City of Franklin
May 27, 2025 10:00 AM City Hall

3.a. Discussion and action request for information from RMV Construction on the flooring demolition

REQUEST FOR INFROMATION

OBSERVATION REPORT

References: Drawing and Pictures

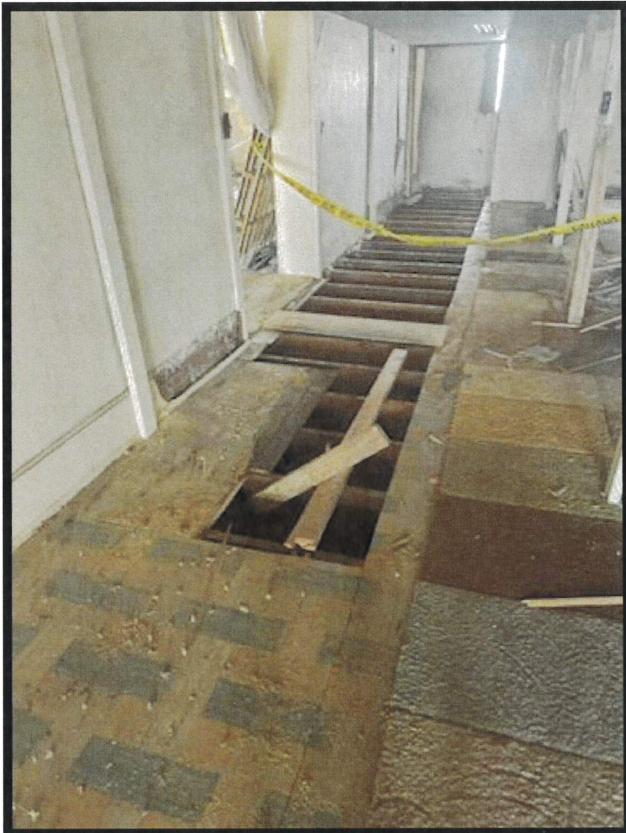
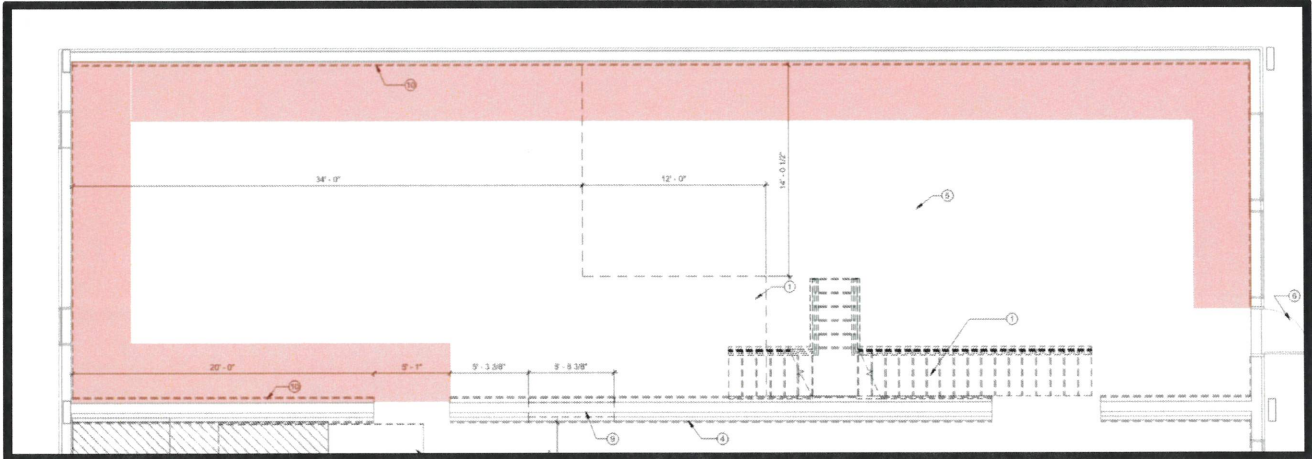
Midwest Plaster & Construction has proceeded with removing some of the existing floors in the north portion of the 1st floor. It is approximately 4' wide and to the extent depicted in the drawing and pictures.

Is Midwest Plaster & Construction replacing what they removed or how are we to proceed?

Please advise.
